**DANE COUNTY DEPT. OF
PUBLIC WORKS, HIGHWAY &
TRANSPORTATION**

ADDENDUM

RFB NO. 317035 - ADDENDUM NO. 1

COLISEUM PERFORMANCE AREA LIGHTING & RIGGING UPGRADES

SCALE IN FEET 1 : 30

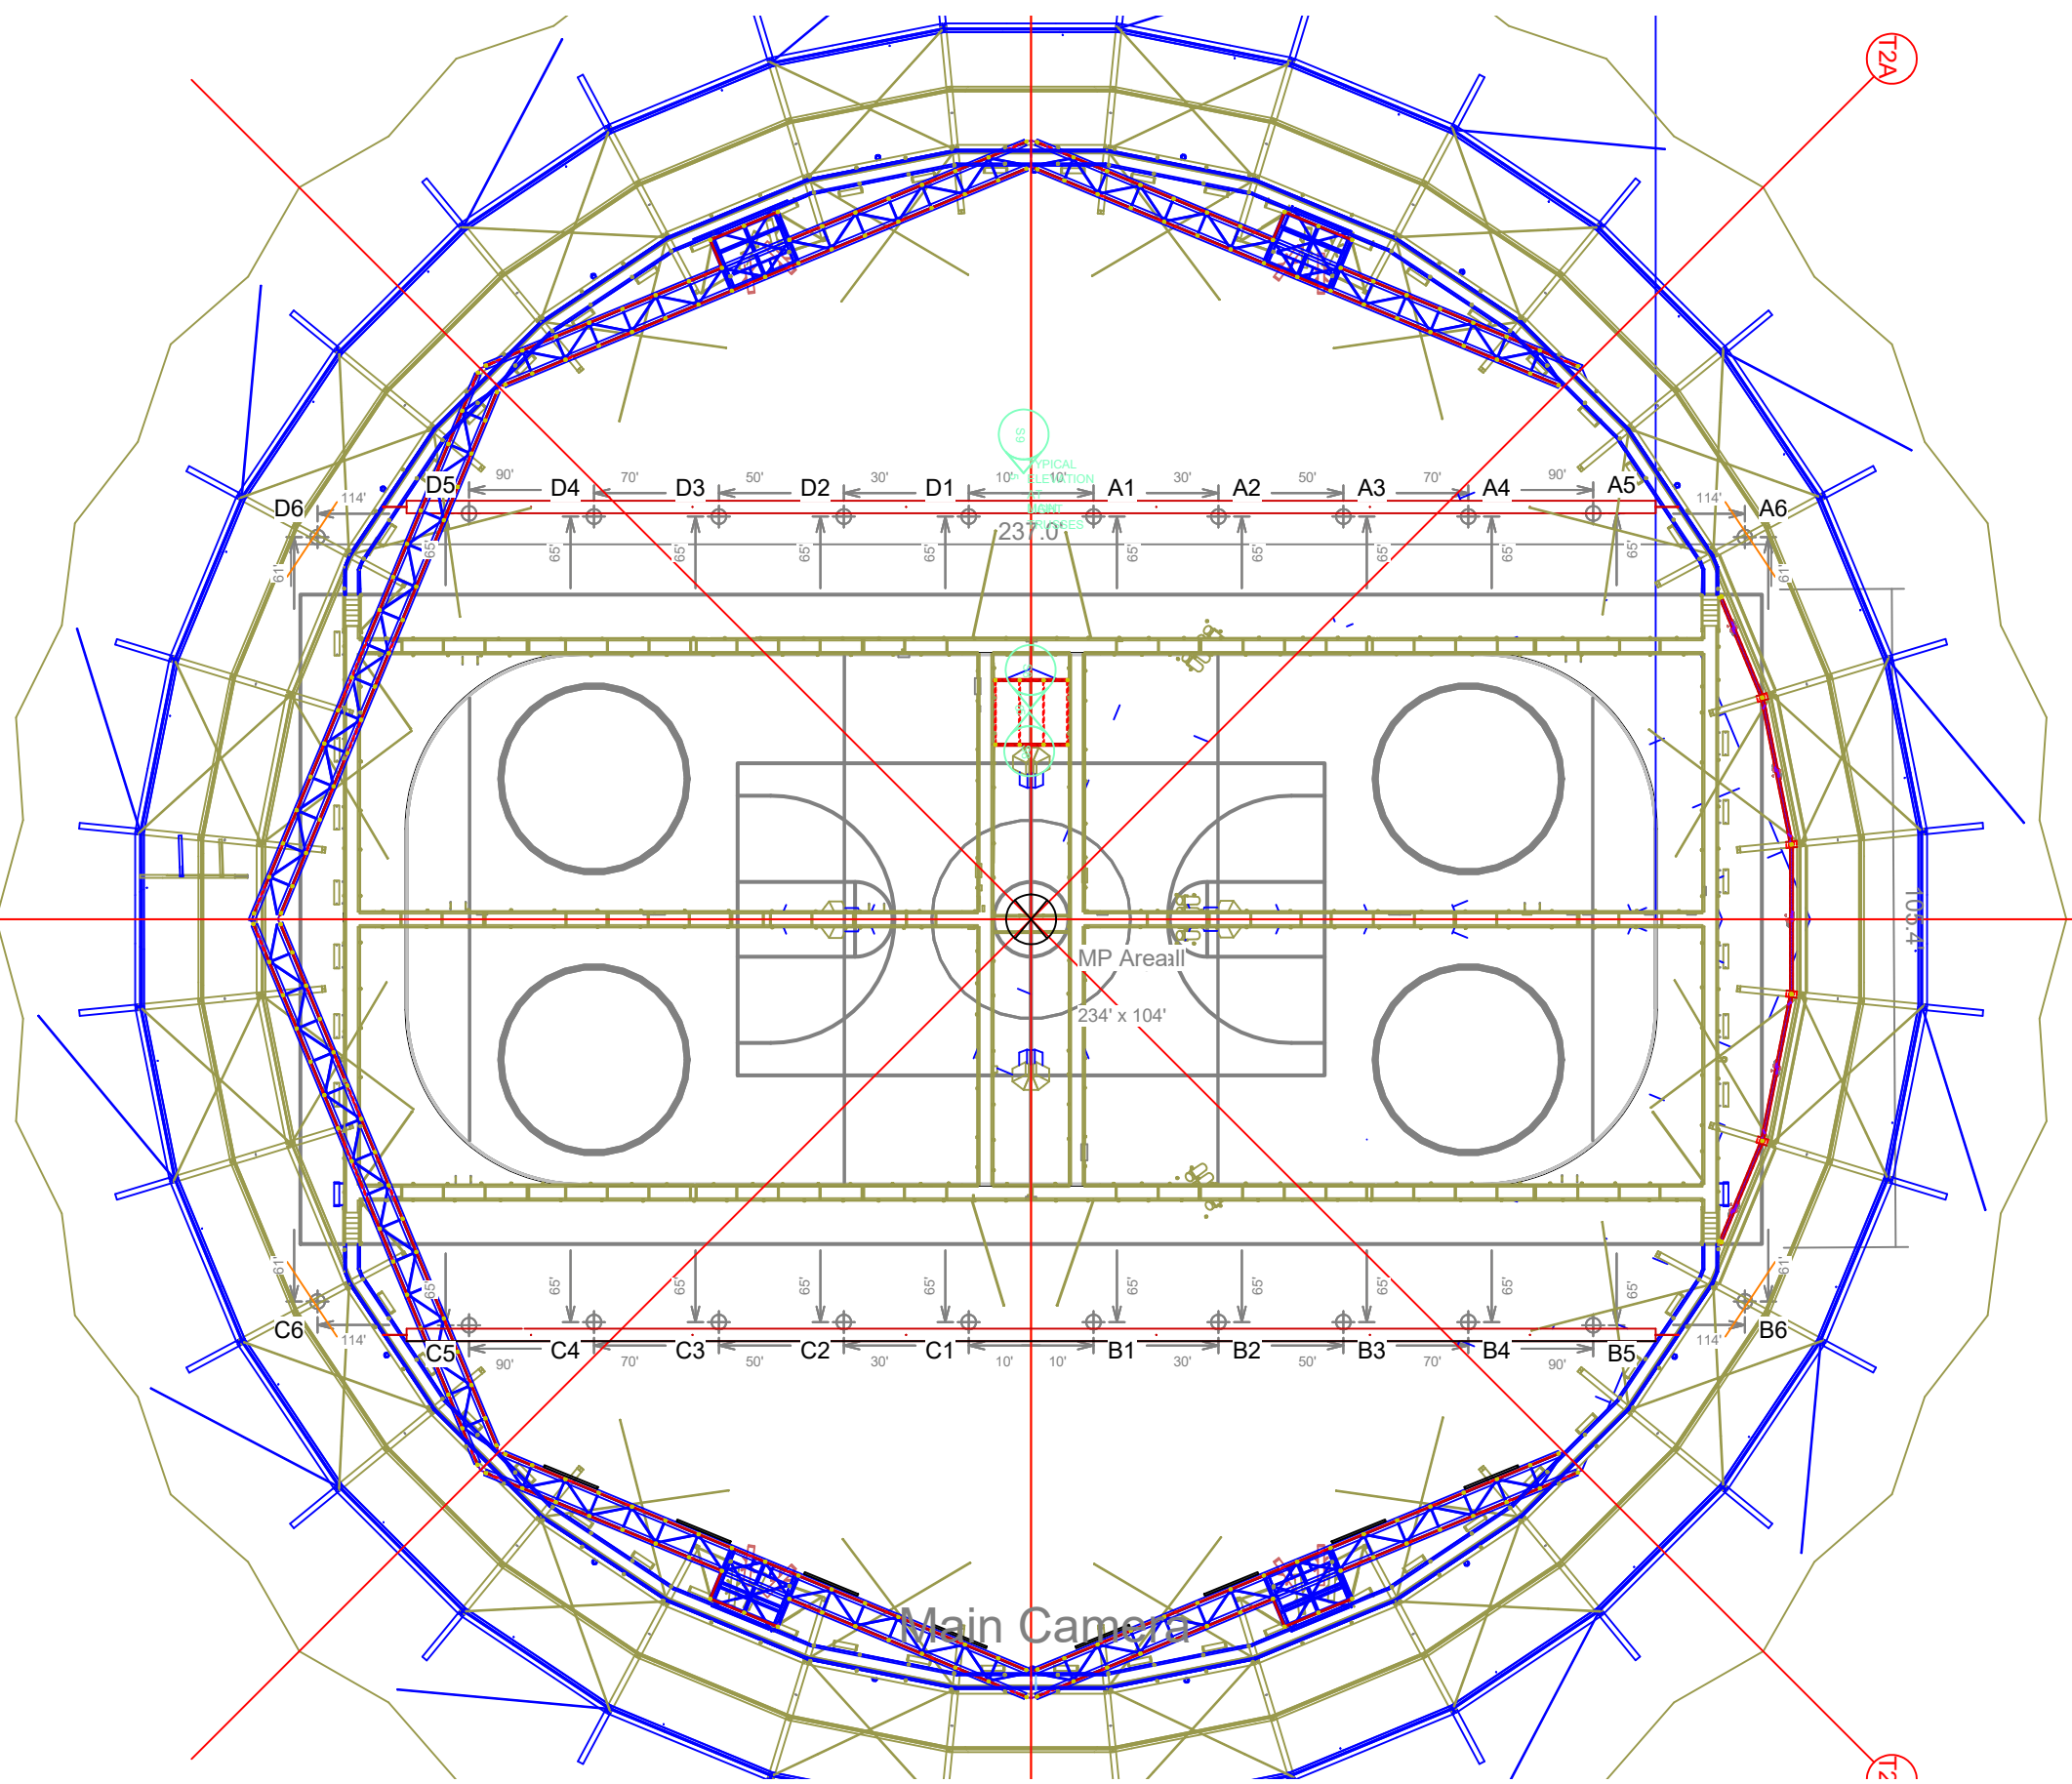
Delete current Exhibit 1; replace with new Exhibit 1, issued with this Addendum.

EXHIBIT 2

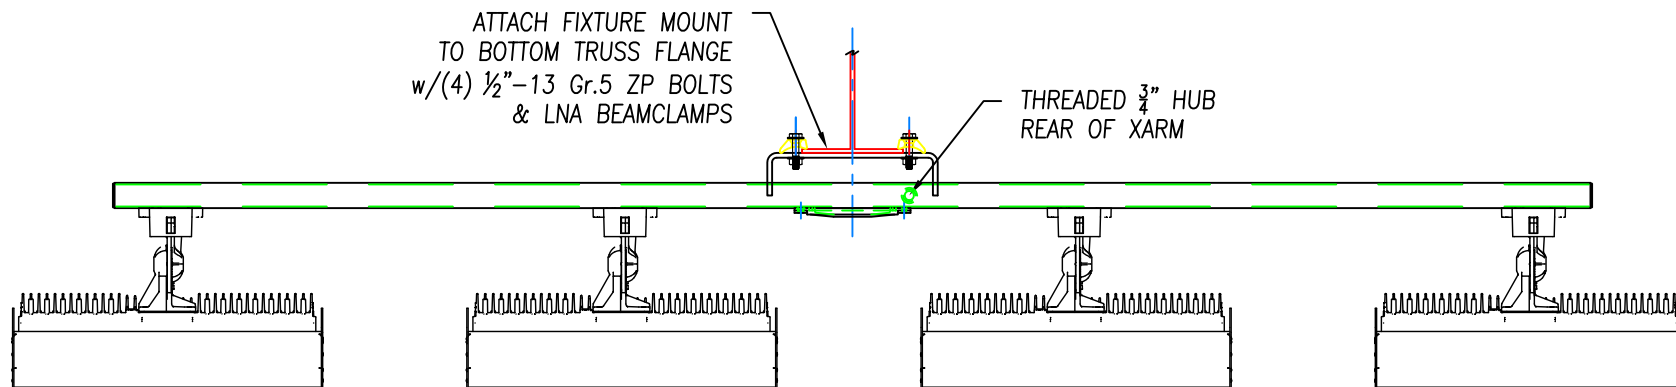
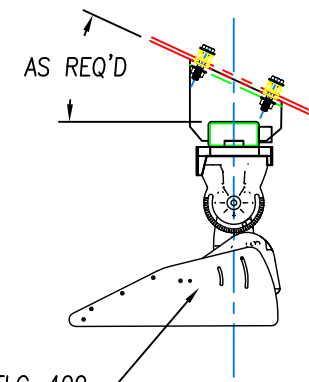
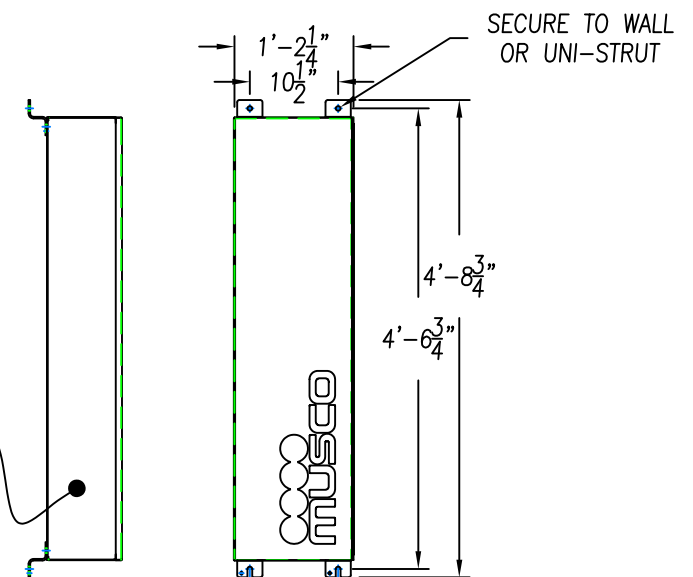
Delete current Exhibit 2; replace with new Exhibit 2, issued with this Addendum.
